**BOARD OF ZONING ADJUSTMENT
STAFF REPORT**

Date: October 3, 2016

5919/5866

New Cingular Wireless PCS, LLC

DETAIL SITE PLAN

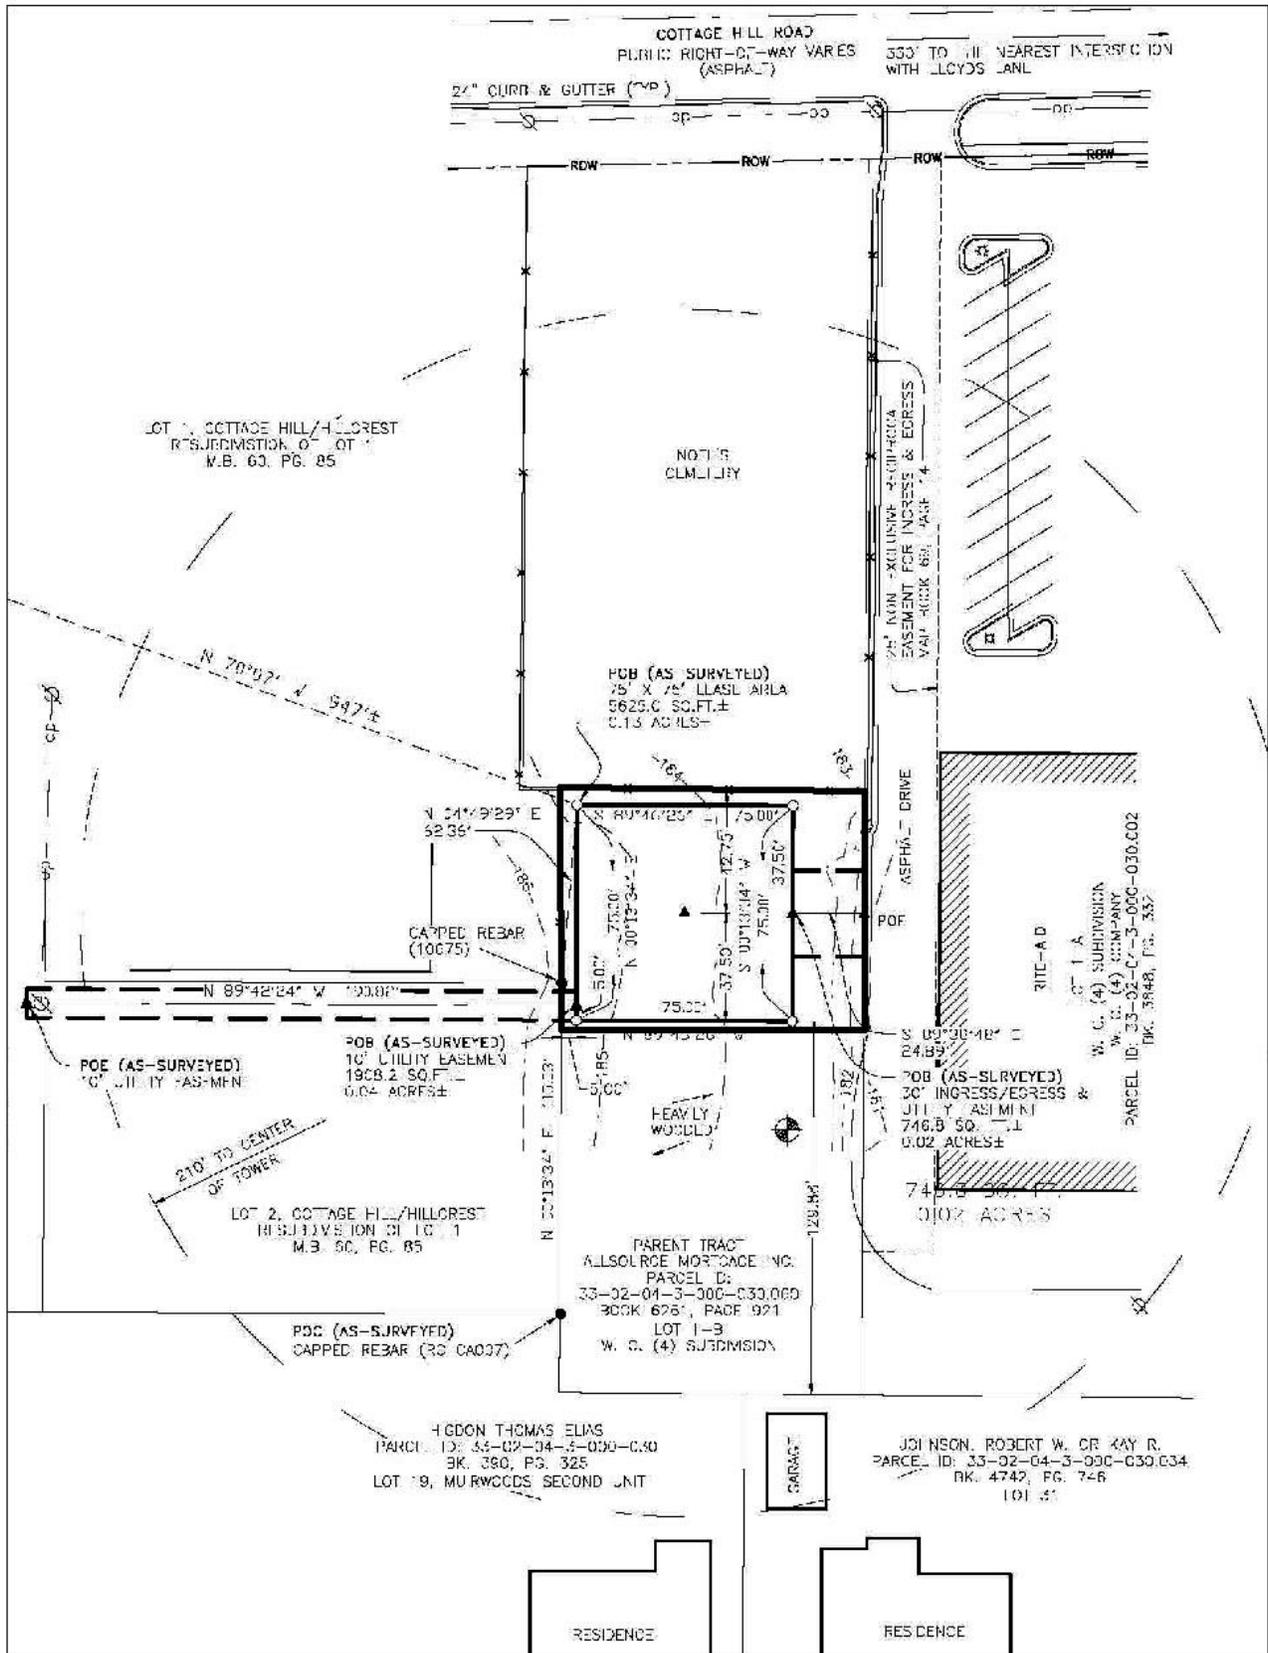
With regard to the Setback and Residential Buffer requests, the applicant states that the requirement to meet the Zoning Ordinance provisions for setbacks and residential buffer present a specific unnecessary hardship due to the constraints of the small parcel. It is stated that neither of these hardships is economic in nature or self-imposed by the applicant and it is believed that the proposal to place the proposed tower within a wooded area on the property best serves the need to provide the least visually obtrusive alternative. As the site is limited in area by surrounding properties, a hardship is illustrated in meeting the required lease parcel setbacks and the Setback Variance request would be justified. And as the technical data submitted supports the selection of this location for the proposed tower, and as a hardship in meeting the Residential Buffer Separation requirement is imposed by the site's location, the Residential Buffer Separation Variance would be justified. Although the closest residentially-zoned property is a cemetery approximately 43' North of the proposed tower, a single-family residential subdivision is located approximately 145' South of the proposed tower. Due to the proximity of the residential property to the South, the applicant has proposed a 6' wooden privacy fence around the tower compound. However, the site plan should be revised to indicate an 8' high fence as required by the Chart of Permitted Uses of the Zoning Ordinance.

The site plan submitted indicates a contiguous hedge of evergreen shrubs around the tower compound and eight overstory trees beyond. However, the three trees indicated to the South of the compound are actually indicated to be on the adjacent separate proposed lot to the South. Therefore, only five overstory trees are indicated as actually proposed on the tower site, and the lot perimeter would require twelve overstory trees. The applicant bases the Tree Planting Variance request based on the proposed site mostly being surrounded by existing mature trees. However, some trees would have to be removed to develop the tower site and no hardship has been illustrated to justify the granting of the Tree Planting Variance request, especially in light of the fact that sufficient area would be provided by the clearing for the tower lease parcel to provide the required number of trees.

- 1) the tower is limited to a monopole design with an over-all height of 150', including the antenna extension and the lightning rod;
- 2) revision of the tower elevation to indicate that no communications equipment or lightning rod extends above the 150' elevation above grade;
- 3) revision of the site plan to indicate an 8' high wooden privacy fence around the tower compound as required by the Chart of Permitted Uses of the Zoning Ordinance;
- 4) provision of further overstory trees within the lot perimeter to be coordinated with the Planning Division of the Urban Development Department;
- 5) subject to the Planning Commission approval of the Planning Approval and two-lot Subdivision applications; and
- 6) full compliance with all municipal codes and ordinances.
